Urgent: Important Safety Update
Medical Device Correction for the AFX[®] Endovascular AAA System

This letter provides important information related to the AFX Endovascular AAA System (AFX System) which is intended for the endovascular treatment of patients with abdominal aortic aneurysms (AAA). In previous safety updates, Endologix has provided information on the rates of Type III endoleaks and suggestions for patient surveillance and treatment. This notification provides the following additional information:

Figure 1: AFX Implant Design

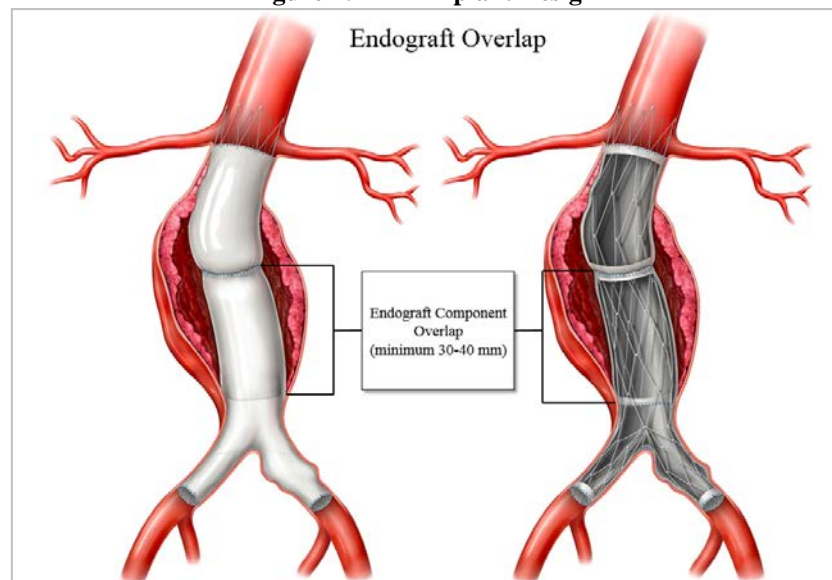
Endologix recognizes there may be a clinical need to either perform an intervention through a previously implanted AFX device (e.g., to gain vascular access for a coronary procedure), or a re-intervention on such a device (e.g., for treatment of a Type III endoleak). As illustrated in **Figure 1**, the AFX implant has a unique endoskeleton design where the ePTFE is only attached to the most proximal and distal stent apices of the implant. The ePTFE is not attached to the stent cage throughout its entire length.

Based on this unique design, Endologix has developed guidelines that should be considered in intervention/re-intervention situations to ensure that devices can be tracked through the previously implanted AFX device without damage. This includes step-by-step instructions on how to best navigate the endoskeleton design of the existing AFX device in order to obtain and confirm proper wire access. These guidelines are intended to help

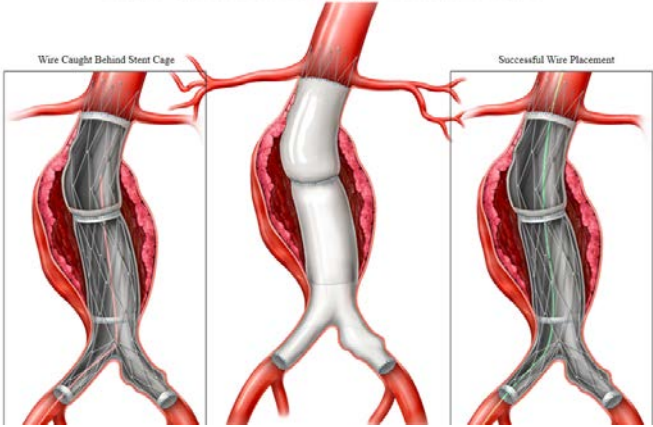
<p>14.2: Imaging Guidelines and Post-Operative Follow Up</p>	<p>Procedurally, fluoroscopic imaging in multiple planes should be used to verify that no accessory devices are placed behind a stent strut (Reference Figure 4). Imaging should also be used after device placement to ensure the existing AFX device has not been damaged and to ensure that the reason for the re-intervention has been addressed.</p> <p>Assuming no additional concerns have been identified, Endologix recommends, at a minimum, that high-resolution CT scan (contrast-enhanced and non-contrast) imaging follow-up to be performed at one month, six months, one year, and annually thereafter following any re-intervention. Alternative imaging modalities such as magnetic resonance imaging, plain X-Ray or duplex ultrasound may be used in patients with impaired renal function or intolerance to contrast media. Determination of imaging techniques should be based on the physician's clinical assessment of the patient and stent graft implant, including any adjunct procedures that may have been performed in conjunction with the endovascular stent graft procedure.</p>

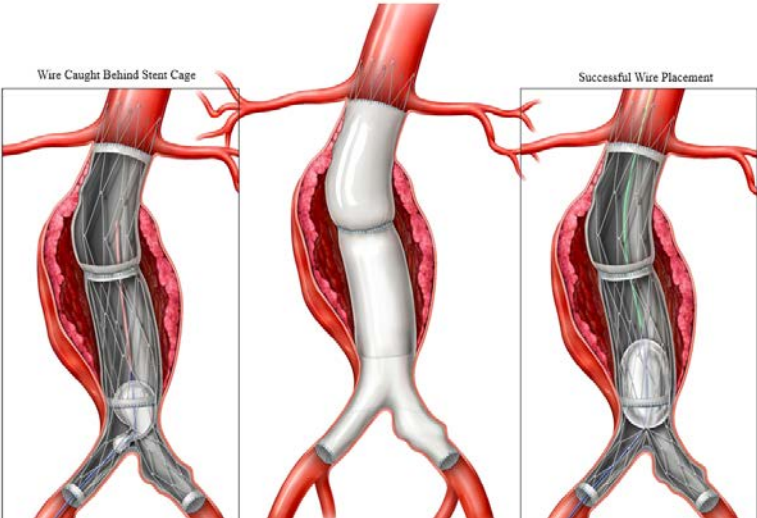
New IFU Section	Content
<p>13.3: Patient Preparation/ Arterial Access</p>	<ol style="list-style-type: none"> 1. Refer to institutional protocols relating to anesthesia, anticoagulation and monitoring of vital signs. 2. Position patient on imaging table allowing fluoroscopic visualization from the aortic arch to the femoral bifurcations. 3. Gain luminal access through the femoral arteries. 4. Establish adequate proximal and distal vascular control of the surgically exposed femoral artery, as needed. 5. Following the manufacturer’s instructions for use, advance a flexible “J-tip” guidewire, pigtail catheter, or acceptable equivalent, into the vasculature under fluoroscopy. <ul style="list-style-type: none"> • NOTE: Proper device choice may limit the likelihood of tracking behind a stent strut. Reference Figure 4. <p style="text-align: center;">Figure 4: Ensure Guidewire Is Not Caught Behind Stent Strut Ensure Guidewire is Not Caught Behind Stent Strut</p>  <p style="text-align: center;"><i>*Note: Figure 4 corresponds to Figure 17 of the IFU</i></p> <p>CAUTION: <i>Tortuosity and angulation may impact the morphology of the endoskeleton within the vasculature. Use caution when tracking devices through the existing AFX device.</i></p> 6. Once the flexible “J-tip” guidewire or pigtail catheter reaches above the existing AFX device, slowly advance an occlusion balloon or PTA balloon over the wire and under fluoroscopy. Slowly inflate, per the manufacturer’s instructions, until the balloon has been fully shaped or formed. It is recommended to use a 12mm diameter PTA balloon or an occlusion balloon that is partially inflated to ensure devices are not behind a stent strut. <ul style="list-style-type: none"> • Advance and retract the balloon catheter up and down the entire length of the existing AFX device to ensure there is proper luminal wire access. <ul style="list-style-type: none"> ○ NOTE: Balloon kinking during inflation or enlargement of a section of the stent cage may be a signal of a potential wire placed behind a stent strut. Reference Figure 5.

New IFU Section	Content
	<p>Figure 5: Use of a Balloon to Confirm Correct Placement of Guidewire</p> <p>Use of a Balloon to Confirm Correct Placement of Guidewire</p>  <p><i>*Note: Figure 5 corresponds to Figure 18 of the IFU</i></p> <p>CAUTION: <i>Balloon inflation and advancement should be performed slowly so as not to damage or dislodge the existing AFX device.</i></p> <p>WARNING: <i>Overinflation of the balloon to ensure luminal access may create the false appearance of a wire placed behind a stent strut or may shift the main body cephalad.</i></p> <ol style="list-style-type: none"> 7. During inflation and while tracking through the aortic lumen, fluoroscopic imaging in multiple planes should be used to verify that no accessory devices are behind a stent strut. 8. After verifying correct wire placement fluoroscopically, the balloon should be removed and use of alternative techniques (e.g., intravascular ultrasound) may be helpful to confirm correct wire placement. 9. Should incorrect wire placement behind a stent strut be observed, remove wire and re-advance guidewire/pigtail catheter, as described above. 10. Repeat Steps 5-8 for contralateral access, if appropriate.
